Access Compliance Report

Public Rights-of-Way

Intersection ID: 53425	Main Street: HOUSTON_FIELD_CT	Cross Street: PROVIDENCE_RD	Location: SE
ADA ID: 6CD6E66178FB	Ramp Type: Perp	Initial Pass/Fail: Fail	Overall Compliance: No
		Severity Score: 8.75

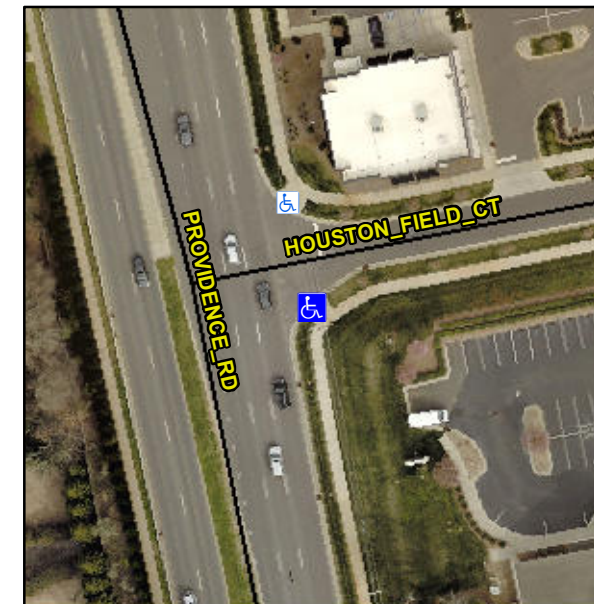
Not Found, R304.5.1

Compliance	Description	Data	Compliance	Description	Data
N/A	Ramp Length (in)	102.0	Yes	Ramp Slope (%)	6.0
No	Ramp Width (in)	46.0	Yes	Ramp XSlope (%)	0.9
N/A	Flare Type LT	N/A	N/A	Flare Type RT	N/A
N/A	Flare Slope LT (%)	N/A	N/A	Flare Slope RT (%)	N/A
N/A	Flare Traversable LT?	N/A	N/A	Flare Traversable RT?	N/A
N/A	Landing Length (in)	N/A	N/A	DWS Provided?	N/A
N/A	Landing Width (in)	N/A	N/A	DWS Contrast?	N/A
N/A	Landing Slope (%)	N/A	N/A	DWS Length (in)	N/A
N/A	Landing X Slope (%)	N/A	N/A	DWS Full Width?	N/A
N/A	Landing Curb? (Y/N)	N/A	N/A	DWS Offset (in)	N/A
N/A	Shared Landing?	N/A			
N/A	Gutter Ponding?	N/A	N/A	Gutter Slope (%)	N/A
N/A	Gutter Lip Ht (in)	N/A	N/A	Gutter X Slope (%)	N/A
N/A	Painted X Walk1?	No	N/A	Painted X Walk2?	N/A
	X Walk 1 Direction	To N		X Walk 2 Direction	N/A
N/A	X Walk 1 Width (in)	N/A	N/A	X Walk 2 Width (in)	N/A
	X Walk 1 Slope (%)	2.1		X Walk 2 Slope (%)	N/A
	X Walk 1 X Slope (%)	0.9		X Walk 2 X Slope (%)	N/A

Remove & Replace Entire Ramp.
